**Approved Version of Instrument Setpoint Methodology for the Kairos Power
Fluoride Salt-Cooled High-Temperature Reactor
(Non-Proprietary)**

SUBJECT: KAIROS POWER LLC – FINAL SAFETY EVALUATION OF TOPICAL REPORT,
“INSTRUMENT SETPOINT METHODOLOGY FOR THE KAIROS POWER
FLUORIDE SALT-COOLED HIGH-TEMPERATURE REACTOR,” REVISION 1
(CAC NO. 000431 / EPID NO: L-2023-TOP-0033)

**KAIROS POWER LLC – FINAL SAFETY EVALUATION OF TOPICAL REPORT
KP-TR-021-NP, “INSTRUMENT SETPOINT METHODOLOGY FOR THE KAIROS POWER
FLUORIDE SALT-COOLED HIGH-TEMPERATURE REACTOR,” REVISION 1
(CAC NO. 000431 / EPID L-2023-TOP-0033)**

Figure 1 Setpoint Parameter Relationships (TR Figure 1)

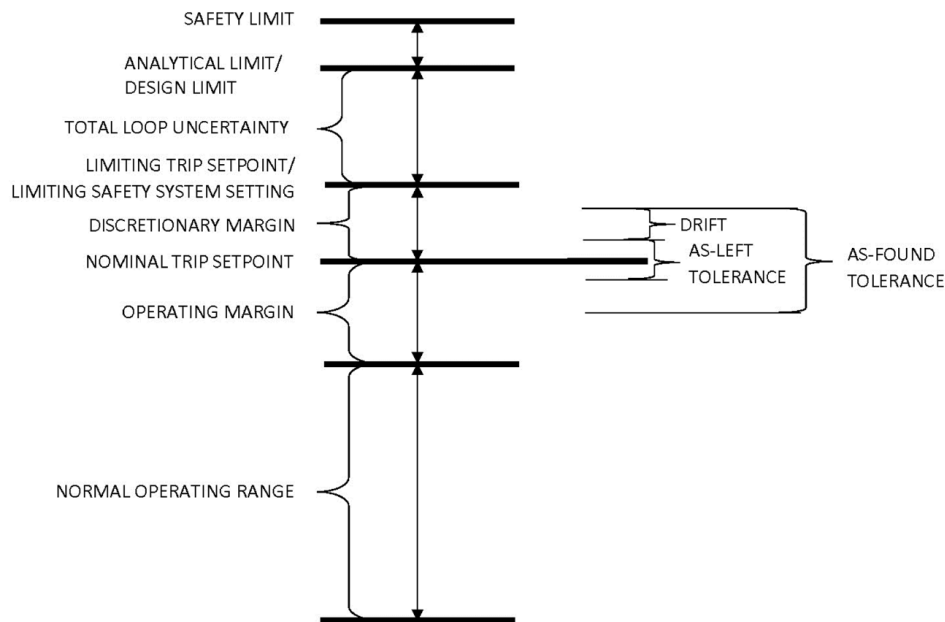
The NRC staff reviewed TR Figure 1, “Setpoint Parameter Relationships,” shown below in Figure 1, and compared it to Figure 1, “Relation Between Setpoint Parameters,” of ANSI/ISA-67.04.01-2018 (ANSI Figure 1) which depict relationships between various setpoints, margins, limits and other setpoint parameters. RG 1.105, Revision 4, states that “Figure 1 of ANSI/ISA 67.04.01-2008 [(ANSI Figure 1)] illustrates setpoint relationships for nuclear safety-related setpoints.” The NRC staff determined that the TR Figure 1 is comparable to ANSI Figure 1 in that the types of setpoints parameters (e.g. setpoints, margin, limits, etc.) and relative relationships are represented similarly. For these reasons, the NRC staff finds that the Kairos setpoint methodology conforms to RG 1.105, Revision 4, with respect to relationships between setpoint parameters for safety-related instrumentation.

Figure 2 Scaling or Conversion Process

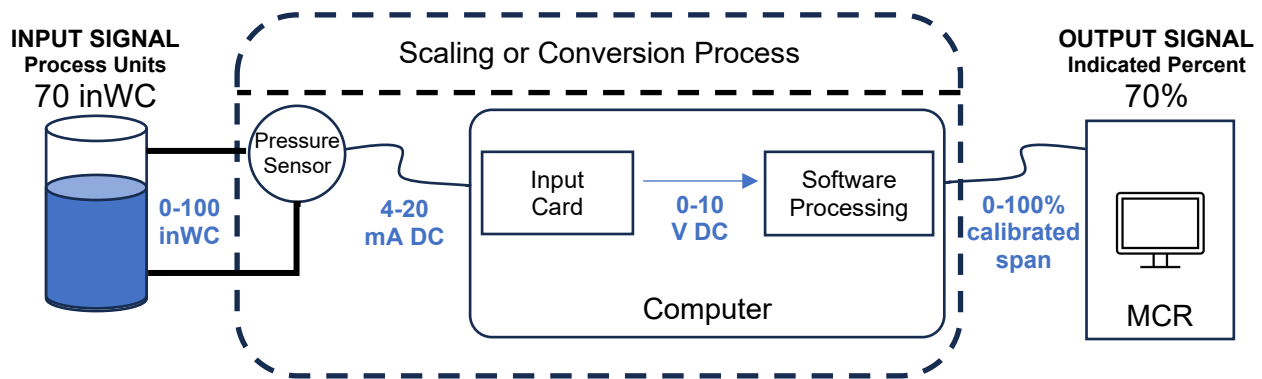
The NRC staff reviewed TR Section 2.4 and noted that although it states that "[i]ndividual uncertainty terms are calculated in terms of percent calibrated span..." it does not describe the relationship between instrument and process measurement units. However, the methodology references ISA-RP67.04.02-2010, which describes this relationship by stating that trip setpoint values usually require transformation from process parameters to voltage or current values. For example, an analog pressure transmitter loop may contain an electronic comparator whose trip setting is measured and set in milliamperes of current. This conversion or scaling process can typically be described as a simple linear equation that relates process variable units to measurement signal units. This scaling process would also apply to ALT and AFT. Although ISA-RP67.04.02-2010 is not endorsed by the NRC, based on its review, the NRC staff determined that the methodology referenced in ISA-RP67.04.02-2010 provides applicable guidance for the implementation of ANSI/ISA-67.04.01-2018.

Using the methodology described in ISA-RP67.04.02-2010, a setpoint provided in percent span is calibrated at the sensor in process units [e.g., sensor input is 0-100 inches of water column (inWC), output is 4-20 milliamp direct current (mA DC), the computer input card input is 4-20 mA DC, output is 0-10 volts (V) DC]. The software converts 0-10 V DC to 0-100 percent span. Thus, a 70 percent span setpoint indication at main control room equates to 70 inWC at the process and is represented below in Figure 2. Additional discussion on the scaling or conversion process is described in ISA-RP67.04.02-2010, Section 9. Based on the above, the NRC staff finds that the Kairos setpoint methodology is consistent with ISA-RP67.04-0210, and therefore conforms to RG 1.105, Revision 4, with respect to converting percent calibrated span into process measurement units within a trip setpoint calculation.
